DANIEL L. CLAASSEN 1ST ADDITION AN ADDITION TO WICHITA, SEDGWICK COUNTY, KANSAS

Final Plat
revised 12-2-98

RE: S/D 98-100 -- One-Step Final Plat of DANIEL L. CLAASSEN ADDITION

CASE NUMBER: S/D 98-100 - DANIEL L. CLAASSEN ADDITION

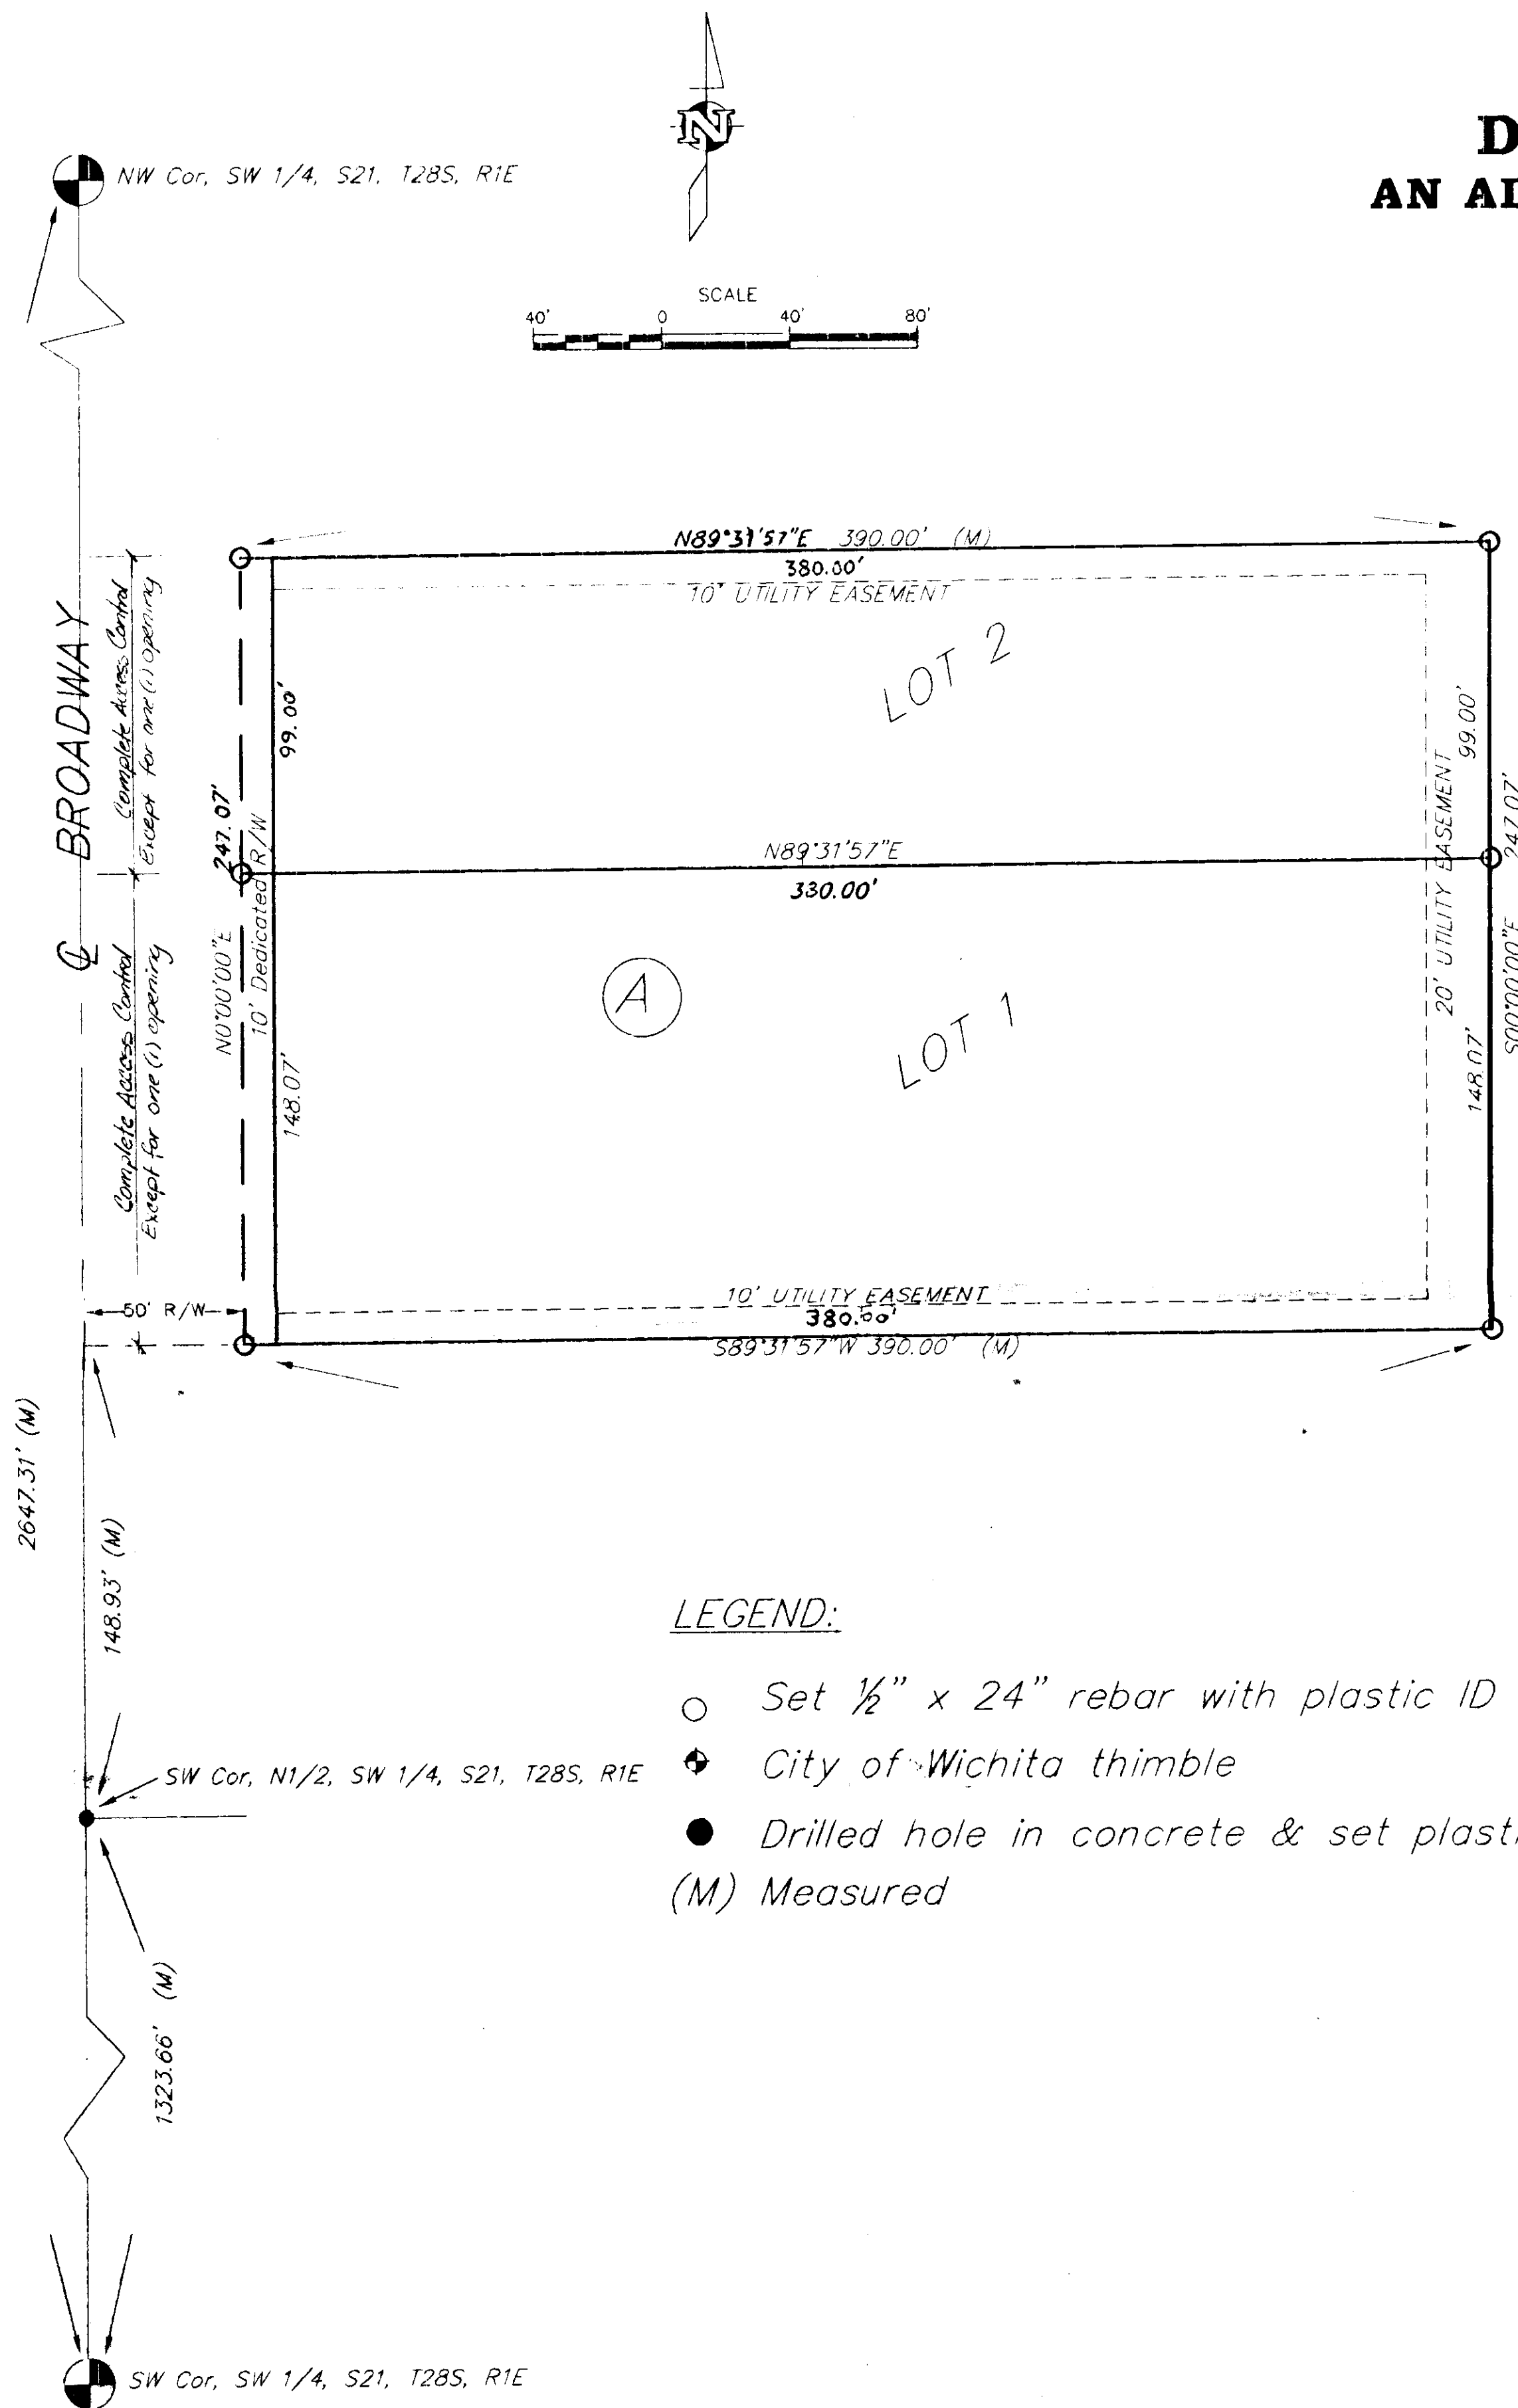
- B. **City Engineering** needs to verify if any guarantees for municipal services or any easements are required. *A guarantee needs to be submitted for a sanitary sewer extension to Lot 1. The Applicant shall contact the adjoining landowner to the south regarding participation in the sewer petition. The utility easement along the rear lot lines needs to be increased to 20 feet to accommodate sanitary sewer. Additional right-of-way needs to be dedicated to line up with the adjoining north and south plats.*

- F. Traffic Engineering needs to comment on the number of allowable access openings along Broadway. The dedication of access controls shall be included on the final plat tracing and referenced in the plat's text. The Applicant shall guarantee the closure of any driveway openings being located in areas of complete access control or that exceed the number of allowed openings. *The final tracing shall denote one opening per lot.*

- G. The spelling of "Claassen" needs to be corrected on the final plat tracing.
- H. The MAPC Chairman needs to be revised to "William M. Johnson".
- I. Traffic Engineering needs to comment on the need for improvements to Broadway.

- J. The Applicant is reminded that a platting binder is required with the final plat tracing.
- K. The lot depth to width ratio exceeds 3 to 1 for Lot 2, and a modification from the Subdivision regulations will be needed for approval of this plat.

- S. The representatives from the utility companies should be prepared to comment on the need for any additional utility easements to be platted on this property. *The Applicant intends to relocate the utility easement between the two lots to the north and south lines of the plat.*
